BCA Assessment Report

Kogarah Golf Club Redevelopment
Concept & Early Works SSDA (SSD-84467726)
13 – 19A Marsh St, Arncliffe

Revision 1

30 April 2026

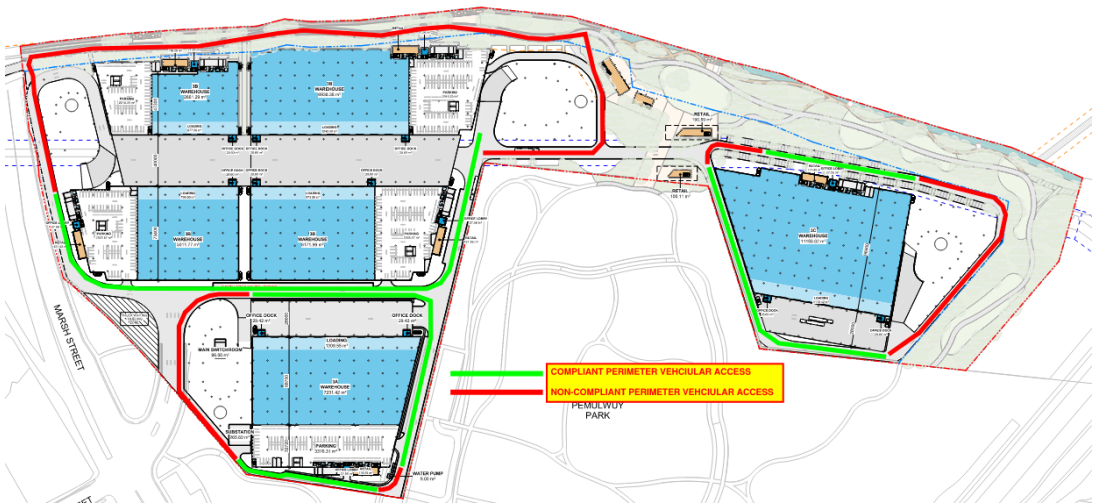
C3D4	Large Isolated Buildings: A Large Isolated Building that contains Class 5, 6, 7, 8 or 9 parts, is required to be— + Protected throughout with a sprinkler system complying with Specification 17; and + Provided with a perimeter vehicular access complying with C3D5(2). Comment: The proposed industrial buildings (Blocks 3A, 3B, & 3C) are required to be sprinkler protected and provided with a 6m wide perimeter vehicular accessway in accordance with Clause C3D5(2) throughout (see notes in C3D5 below).
C3D5	Requirements for Open Spaces and Vehicular Access: Open space and vehicular access required by C3D4 must comply with the requirements of sub-clauses (a) & (b) of this Part whereby they must be 6m wide within 18m of the external walls of the building and of a suitable bearing capacity and unobstructed height to permit the operation and passage of FRNSW vehicles. Comment: The proposed Blocks 3A, 3B, & 3C do not comply with the provisions of C3D5 and thus the following non-compliance issues are required to be addressed as a Performance Solution by the Fire Engineer to demonstrate compliance with Performance Requirement C1P9 – see non-compliances identified in red in Figure 5 below. Particular attention is drawn to the use of the riverside pathway for perimeter vehicular access on the northern side of Block 3B.  <i>Figure 5 Perimeter Vehicular Access Assessment</i>
